**LOS ANGELES CITY PLANNING DEPARTMENT
RECOMMENDATION REPORT**

CASE NO.: DIR-2008-1178-DB-SPP-1A
APPEAL- DENSITY BONUS COMPLIANCE REVIEW
CEQA: ENV-2008-1179-MND
Incidental Cases: None
Related Cases: None
Council District: 2
Plan Area: North Hollywood-Valley Village
Neighborhood Council: Valley Village
Plan Land Use: Medium Residential, High Medium Residential
Zone: R3-1, R4-1

LOCATION: 11933 Magnolia Boulevard, Valley Village

**PROPOSED
PROJECT:**

Showing area that would be blocked by new building

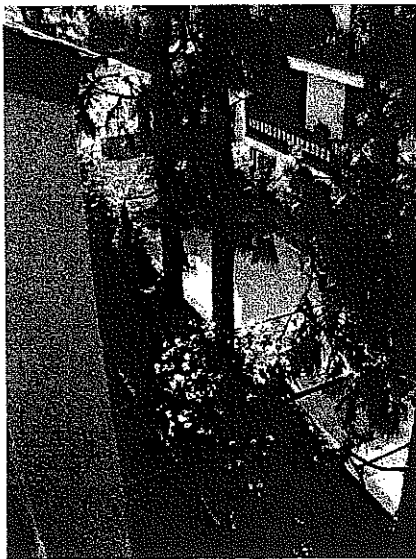
1. The report asserts: "The proposed project does not shade the *roofs* of any multi-unit buildings to the north at any time during year. The **roofs** are not the sole issue. Additionally, these CEQA thresholds have changed since the report was written and therefore is not only non-responsive, it is also not accurate and must be redone.

a. *The CEQA guidelines do not just regulate shading to roofs.* The CEQA guidelines also include "areas that are shade/shadow sensitive including routinely useable outdoor spaces associated with residential, recreational... These uses are considered sensitive because sunlight is important to function, physical comfort, or commerce." **This includes the patios, balconies, pools, and recreational common outdoor space for the buildings to the north, northeast, northwest and those on the east and west of the project.** At 48'7" high, the project does impact these areas of the surrounding buildings significantly, and cannot be mitigated to insignificant because of the closeness of the project to surrounding buildings and the miniscule set backs being put forth.

b. In addition, if roofs of surrounding buildings are also impacted for at least two hours each day, perhaps a more recent interpretation of this impact (not only pursuant to CEQA findings, but also recent analysis) conducted in conjunction with the preparation of the Century City West Specific Plan, needs reevaluation of the exact consequences of doubling the height of building over nearby buildings.

2. As Measure B recently pointed out, Solar energy is going to be a dominant need in the future of electrical planning in LA. With this proposed project towering 2 stories over most of the adjacent projects, there is an unascertained impact to their future supply of solar energy, and could be considered the taking of another's right to the sun. This can not be determined without a thorough study of all sides of this building during all times of the year.

Showing area of significant blockage that would be blocked by new building

Showing current shade, how the bldg will place pool in shade 100% of the time now

Even though this project is well below 60 feet in height and is not subject to the CEQA Threshold of Significance Section A.3.1.c, the applicant has conducted a shade and shadow study in order to provide the Commission with more complete information. **The study concludes that the project at 48 feet, 7 inches is considered well below the CEQA threshold guideline for any significant impact on shading or light blockage.** The project does not shade the roofs of any of the main multi-unit buildings to the north at any time during the year. The roofs of the multi-unit buildings to the east and west are not shaded by the proposed project for more than three hours on the Winter Solstice (between 9:00 a.m. to 3:00 p.m.) nor are they shaded for more than four hours on the Vernal Equinox, Autumnal Equinox or Summer Solstice (between 8 a.m. (9:00 Pacific Daylight Time) to 4:00 p.m. (5:00 Pacific

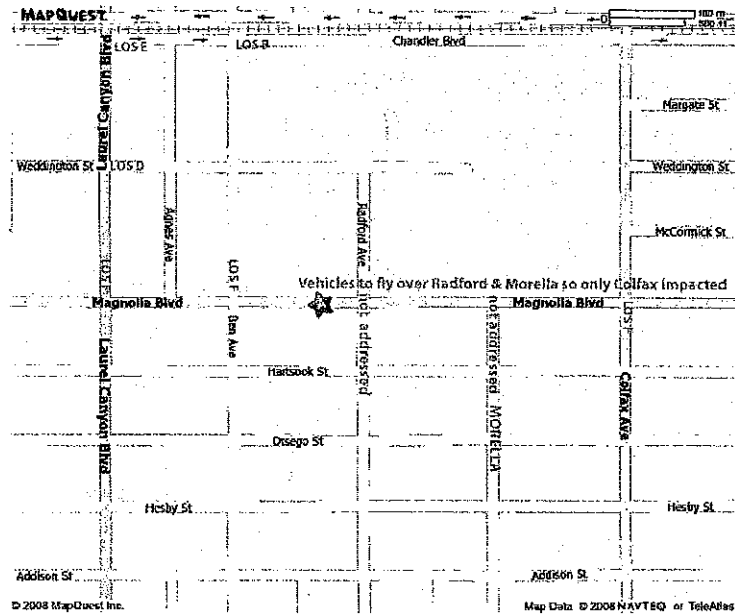
4. The standard used to calculate peak hour trips generated in the report is a national standard from 2003 and bears no relation to Los Angeles traffic. Wendy Greuel admitted to residents at our meeting that she asked for this to be changed and it is not addressed in the traffic report. Simply stated they do not accurately measure peak trips

generated, project volume to capacity ratios, or the impact to intersections from the projects.

5. Traffic counts were generated when the properties were already empty and therefore, calculations must be based on full number of units not just additional units. Traffic counts should have been based on 119 condominiums + 146 apartments (not 56 apartments). This would have added more than 500 trips daily using DOT's standard. *"The project trip distribution was changed slightly to reflect a greater utilization of local streets during the peak hour periods." Streets will be so impossible to traverse that DOT is relying on cut through traffic to make them passable. At the same time reporting that the closest local intersections will not be impacted and therefore, need not be included in the Traffic Study (Magnolia/Radford and Magnolia/Morella).*

6. The closest intersections to the project are NOT addressed, and it is important to do so because they are land locked and they cannot be mitigated to be insignificant. DOT would have the Planning Commission believe that the Colfax and Magnolia intersection is so impacted by this project alone that is requiring the applicant to pay for street improvements on that intersection. However, it is stating that the two intersections in between the project and Colfax/Magnolia are not impacted at all! Are the vehicles going to fly over those two intersections to get to Colfax/Magnolia? If the report addressed these two intersections at Radford/Magnolia and Morella/Magnolia a full EIR would be required according to statute because no mitigations are possible. Instead, they are omitted from the report.

In addition to the MND prepared by the Planning Department, the project was also independently reviewed and analyzed for traffic impacts by the Department of Transportation. The Department of Transportation completed a cumulative traffic assessment for the three proposed residential projects located at 11927-11935 Magnolia Boulevard (project site), 11945-11959 Magnolia Boulevard and 5226-5238 Ben Avenue, at the intersection of Ben Avenue and Magnolia Boulevard in Valley Village. The traffic assessment is based on a traffic study prepared by Hirsch/Green Transportation Consulting, Inc. dated November 26, 2008. After careful review of the pertinent data, DOT has determined that the traffic study, as revised in the letter from DOT, dated March 5, 2009, adequately describes the project related traffic impacts of

The appellant is questioning if DOT has revised their letter. DOT letter dated March 5, 2009 is the revised letter that includes all the corrections and mitigations measures for the project.
